UNITED STATES PATENT AND TRADEMARK OFFICE

APPLICATION NO.	FILING DATE	FIRST NAMED INVENTOR	ATTORNEY DOCKET NO.	CONFIRMATION NO.
10/585,709	07/10/2006	Byung-jin Chun	JCLA21326	7195

Office Action Summary	Application No. 10/585,709	Applicant(s) CHUN, BYUNG-JIN	
	Examiner PINEL E. ROMAIN	Art Unit 4155

DETAILED ACTION***Drawings***

Reference A – Kim (Korean 1988-0003696)

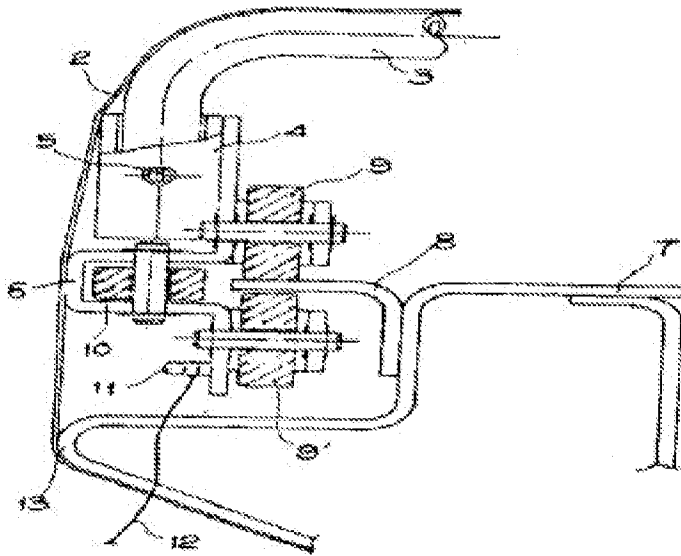
Consider claim 2, SATOMI discloses the apparatus according to claim 1, wherein the guide rail **(41, fig. 1)** includes: a rail frame (42, fig. 6f) having a shape of “c”, the rail frame (42, fig.6f)being installed on each top end of both side walls of the container. However SATOMI does not disclose a guide having a shape “upside down reverse L” of the guide **(41, fig. 1)** being formed on an inner side of a center part of the rail frame to guide the slide of the cover supporting member. Kim discloses a guide (7, reference A, shown below) having a shape “The upside down reverse “L “attached to side of the guide. It would have been obvious to one of ordinary skill in the art at the time of the invention was made to modify the apparatus in claim 1 taught by SATOMI with the inner center guide (7, reference, fig. A) taught by KIM to achieve to

achieve the claimed invention wherein, the bow would have increase stability and reduce binding of the rollers.

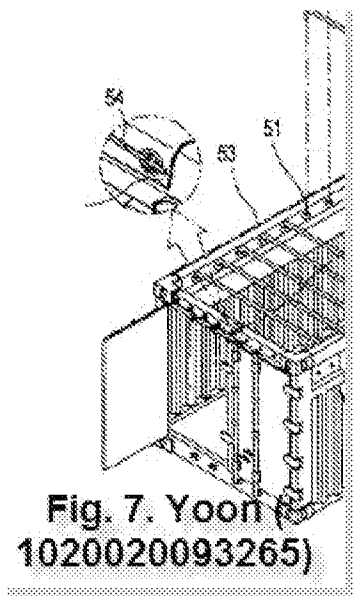
spaced in parallel with the second roller supporting part, to rotatably support the roller slide along the other side surface of the guide. (see fig. below, Kim 1988003696). It would have been obvious to one of ordinary skill in the art at the time of the invention was made motivated to modify apparatus in claim 4 taught by SATOMI with additional rollers taught by KIM to achieve the claimed invention, whereby, the additional rollers would reduce the binding of the cover while being in operations.

Consider claim 6, SATOMI as modified discloses the apparatus accounting claim 5, wherein each of the roller supporting parts (Reference A, above in claim 2) is formed with a center portion (8, reference A). SATOMI as modified does not disclose having a projected rounding shape toward the guide. It would have been an obvious matter of design choice to include a projected round shape toward the guide. Since applicant has not disclosed that rounded shape solves any stated problem or is for any particular purpose and it appears that the invention would perform equally as well with flat or rectangular projection as disclosed. The flat shape would reduce the cost in manufacturing the track support by eliminated an additional machine process.
